Addendum 01

Request for Proposals for Cliff's Hillside Park Renovation Project

Addendum Date: January 23, 2026

Figure 1

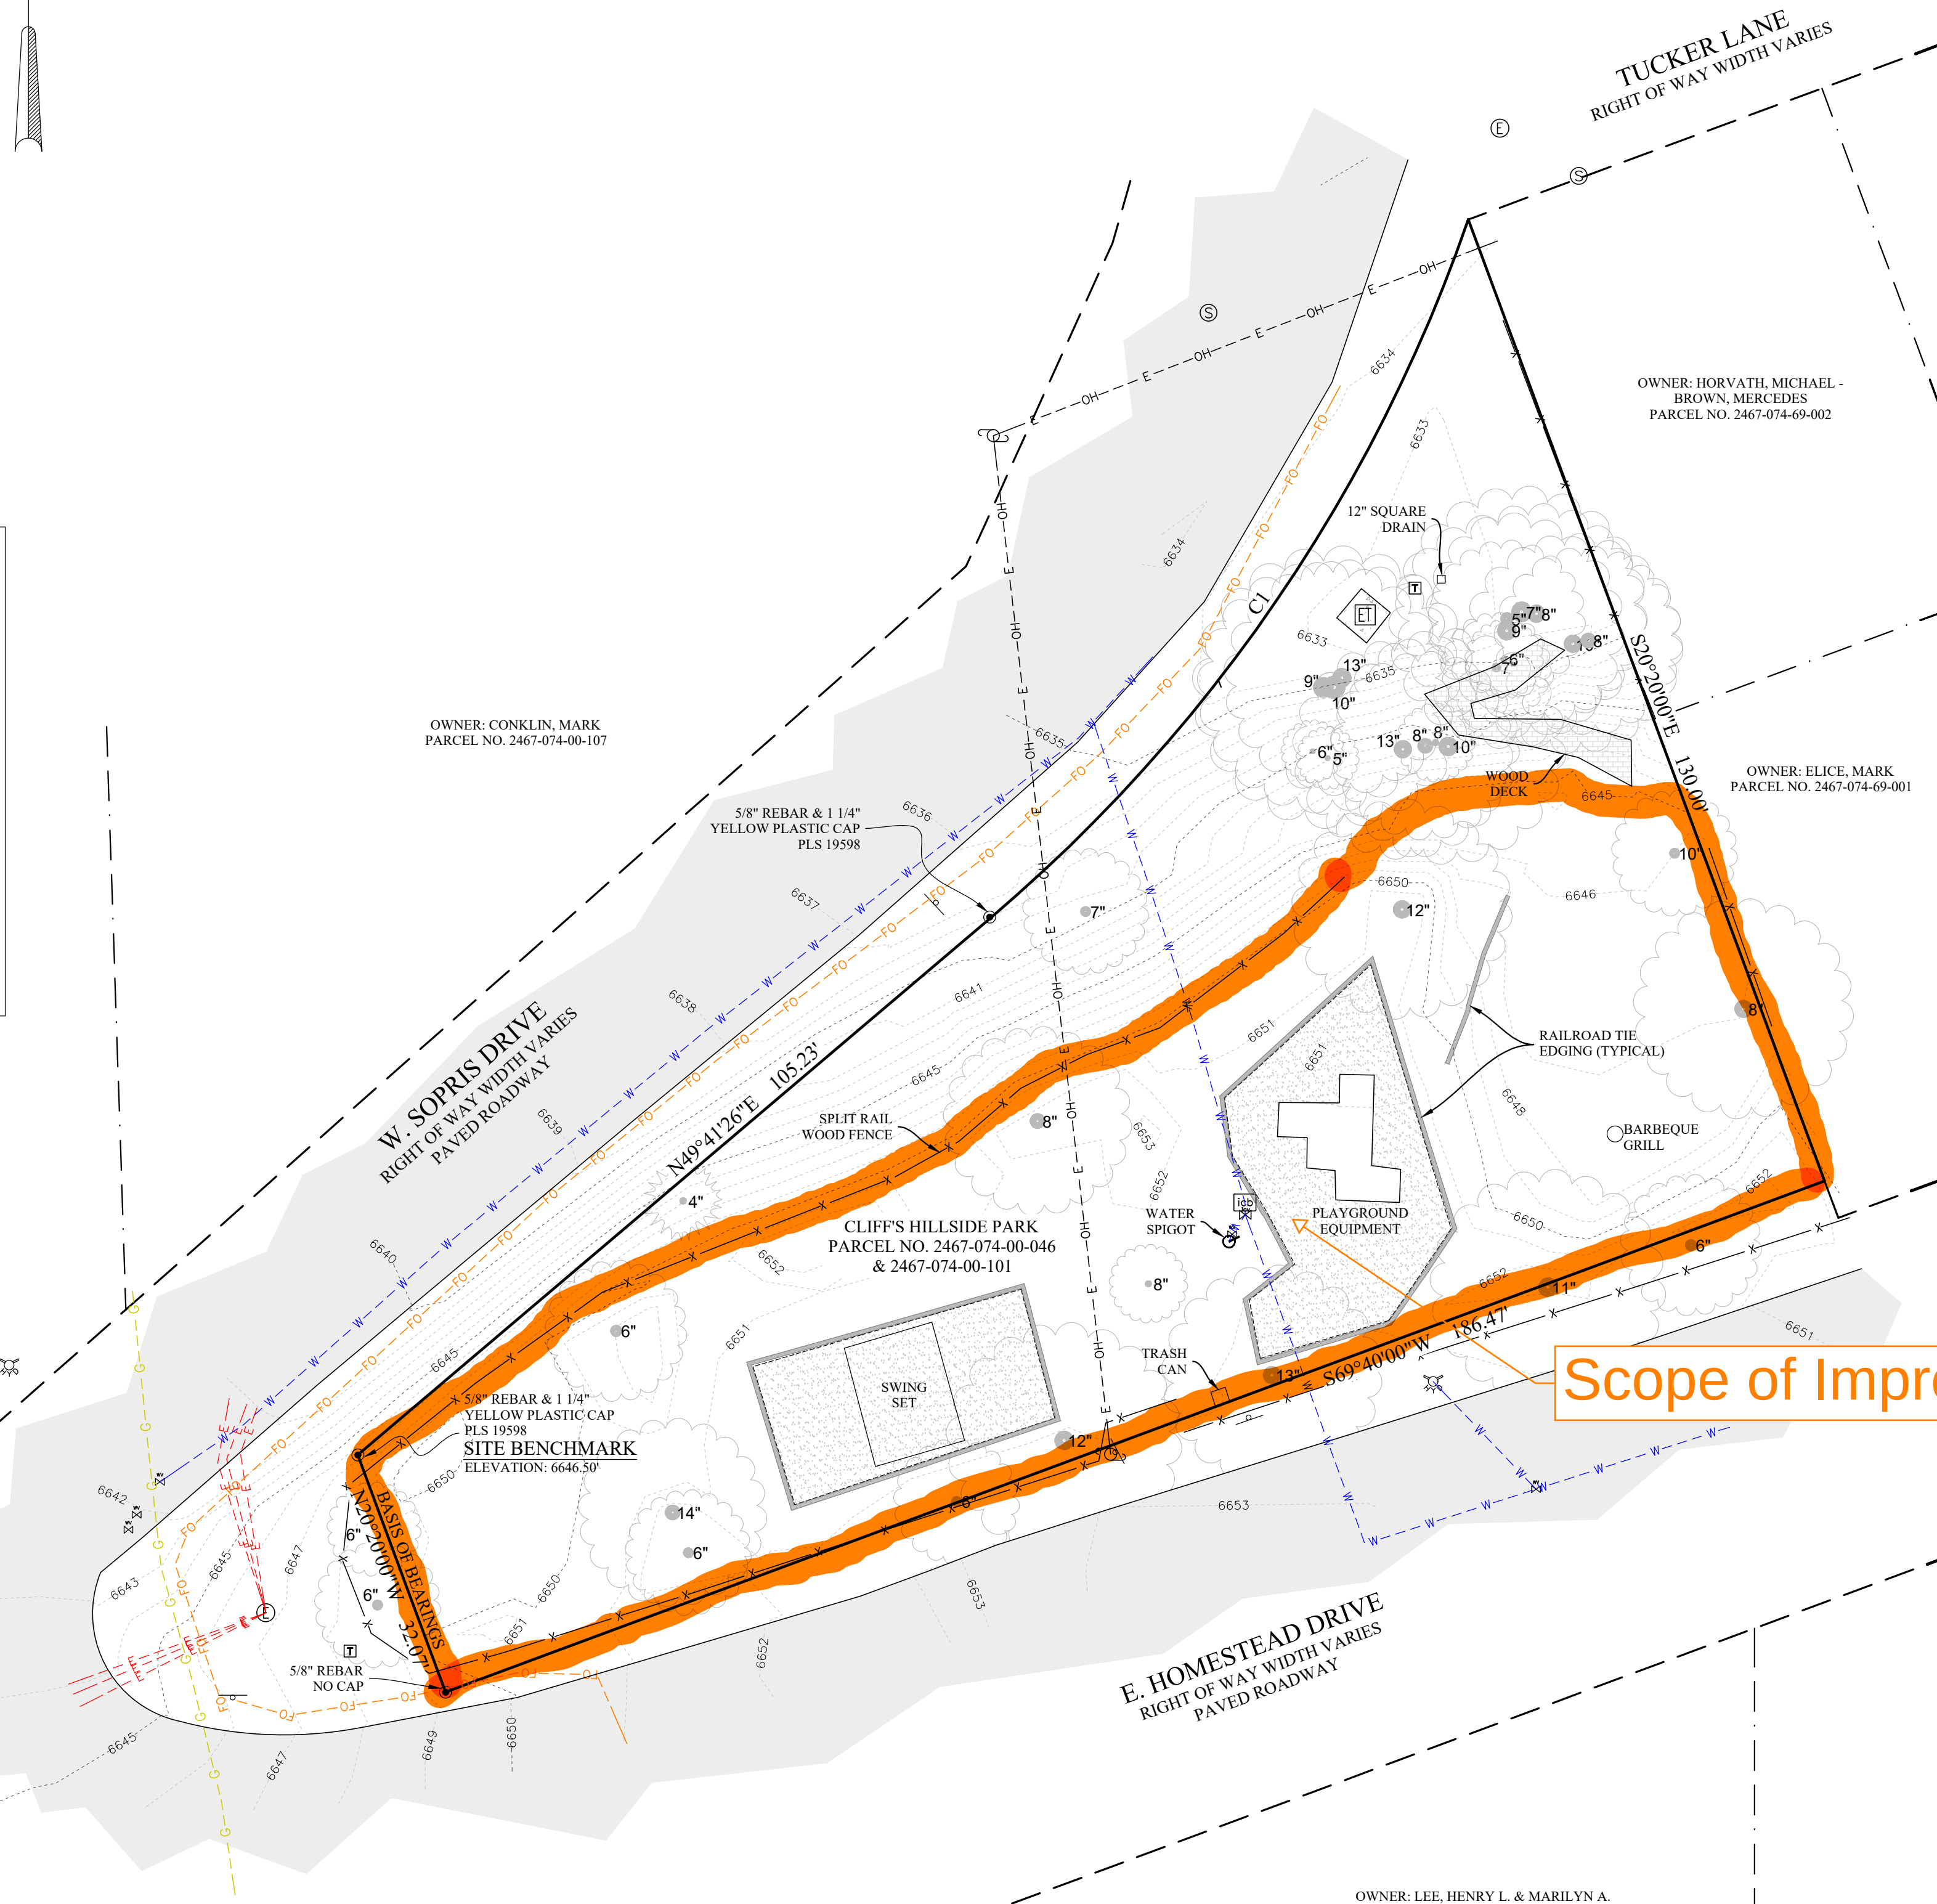
1. The streetlight that will require coordination with Holy Cross Electric and Public Works is shown on the survey on Homestead Drive.
2. The Town will provide the selected contractor with the Town's insurance concerns per CIRSA.
3. A figure has been added, further specifying the improvement area.
4. Play areas and travel within the park should consider ADA accessibility; ADA accessibility outside of the park, including along Homestead Drive, need not be included in the scope.
